**STAFF REPORT AND RECOMMENDATION TO THE DESIGN COMMISSION**

CASE FILE: LU 13-123630 DZM AD  
PC # 12-148566  
REVIEW BY: Design Commission  
WHEN: May 16, 2013 at 1:30 PM  
WHERE: 1900 SW Fourth Ave., Room 2500A  
Portland, OR 97201

The applicant seeks Design Review approval for a new mixed use development, referred to as Block A Apartments, on a portion of the site bounded by NE MLK, NE Multnomah, NE 2<sup>nd</sup> and NE Holladay. The site recently went through a lot consolidation (12-136569 LC) and a Property Line Adjustment (12-143098 PR) that results in its current configuration. The building is proposed in the northeast portion of the site with a shared private driveway straddling the properties to the south and west. Nonconforming upgrades, which are triggered when the value of improvements exceed \$145,200, will apply to these adjacent properties since they are part of the site. Option 2, which allows the required improvements to be postponed for up to two years, will be requested at the time of building permit, since the remaining portion of the site is intended to be redeveloped in the near future.

# SITE PLAN

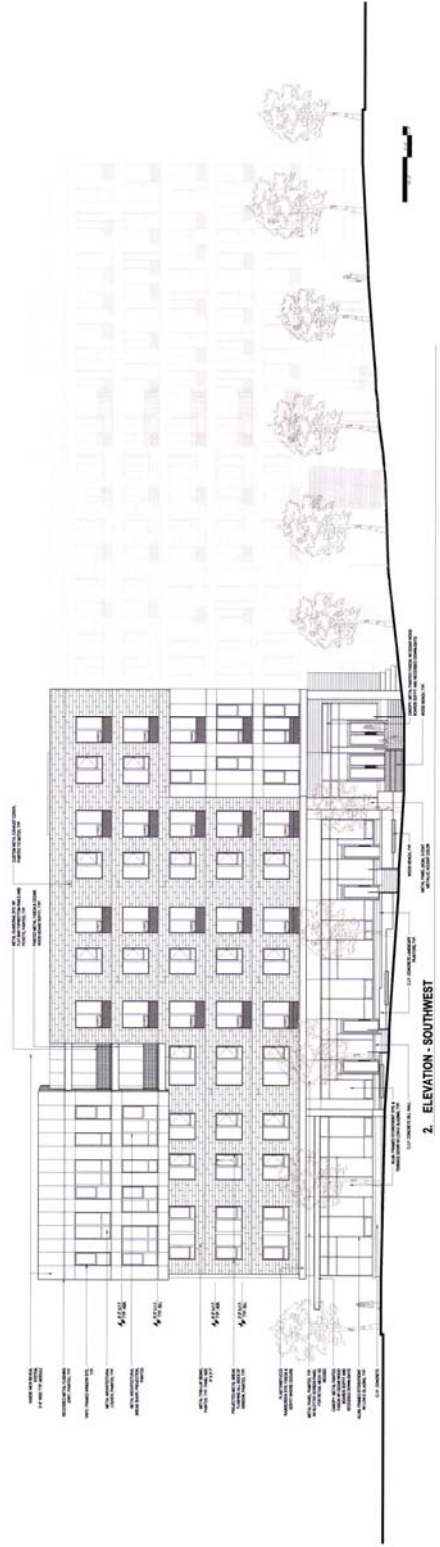
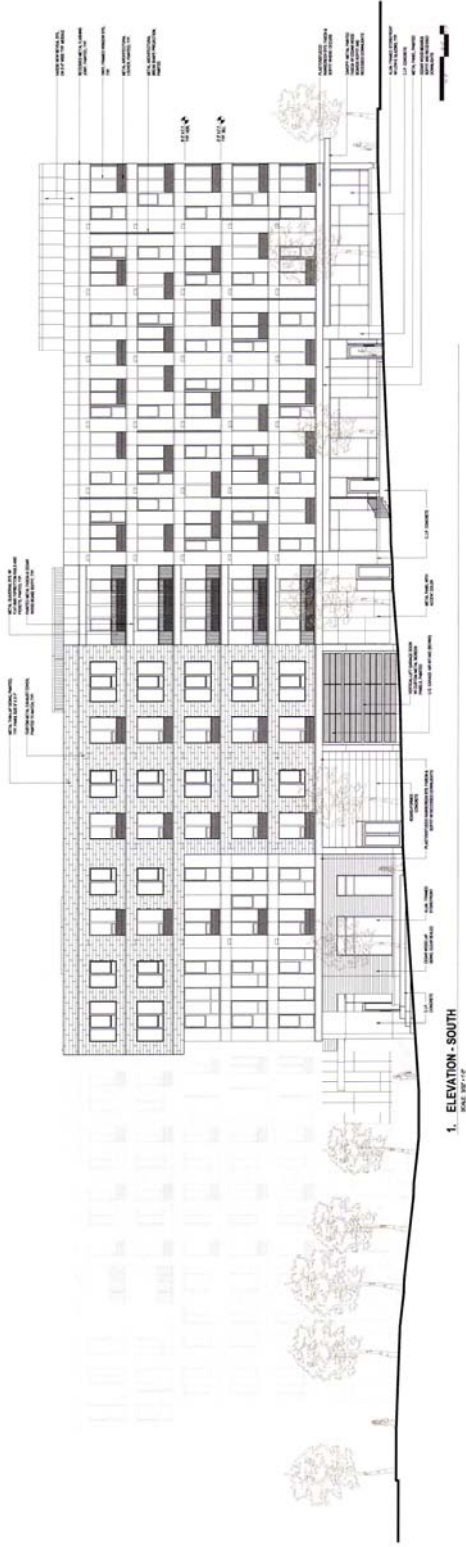
- At the DAR the Commission did support a modification to the 3:1 plaza ratio since the sequenced plazas were more integrated than a proposal that simply met the letter of the law. However, a significant portion of what is indicated as required “plaza” area includes sidewalks and stormwater planters, both of which would have to be provided regardless of the Superblock regulations. As a result, Staff questions the meaningful quality of the defined plaza.

- At the time of the DAR, the retail space at the northwest corner extended to the residential lobby. Under this scenario, Commission questioned if the raised plazas adjacent to these retail spaces were public enough or were they really private outdoor seating areas for the retail patrons. With this area now proposed as stoops for the residential walk-up units, there is a greater concern that these spaces beyond the sidewalk will be even more private.

- It is appreciated this proposal contemplates the next phase of development and a realistic location for the required plaza area. The applicant is not required to do so as part of this review. However, Section 33.293.060, does state, “required walkways, landscaped areas, and plazas for each ownership must be integrated into the previously required walkways, landscaped areas, and plazas of the other ownerships in the superblock”. While this review will not set in stone where the future plazas on the remainder of the superblock go, a plaza location at the southeastern end of the block is not well integrated with the proposed plaza location. This unavoidable dilemma raises a question about sequencing and coordination – should the entire plaza requirement be postponed to the next phase of development on the site to achieve a more meaningful and integrated solution, or should this review dictate more specifically where the next phase of development should focus its public plaza area in relation to what gets approved in this design review?

1. ELEVATION - NORTHWEST

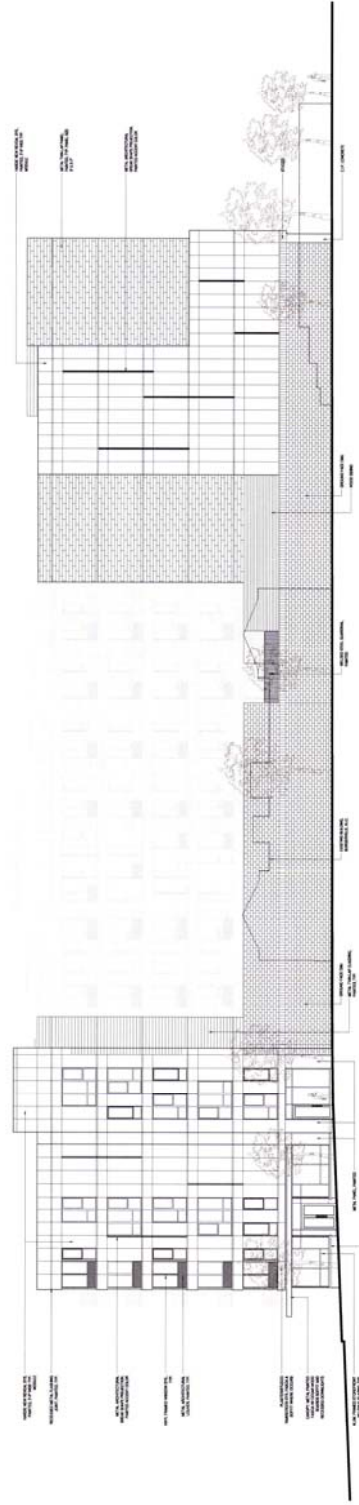
*Staff does have concerns regarding the design of the northwest wall in terms of coherency and quality of materials. Based on the concerns identified in Guidelines C2, C4, C10-1, C10-2, C10-3 and C5 and Section 2, #6, these guidelines have not yet been met.*

The eastern 43’ of this façade contains no glazing due to the proposed utilities (generator and garage intake air) and stair locations within the ground floor. This elevation is comprised of CIP concrete with a solid exit door and metal louver above and 3 adjacent louvered doors. The louvered doors are sized according to the ventilation needs of the generator as is the upper louver for the garage intake air. While these louvers provide some relief and differentiation on this wall, the remaining solid wall area could be treated with a more finished exterior as the other large blank wall facing the private street near the garage entrance, which uses board-formed concrete. Incorporating board-formed concrete on this prominent elevation would better meet guidelines C10-2 (Design Exterior Building
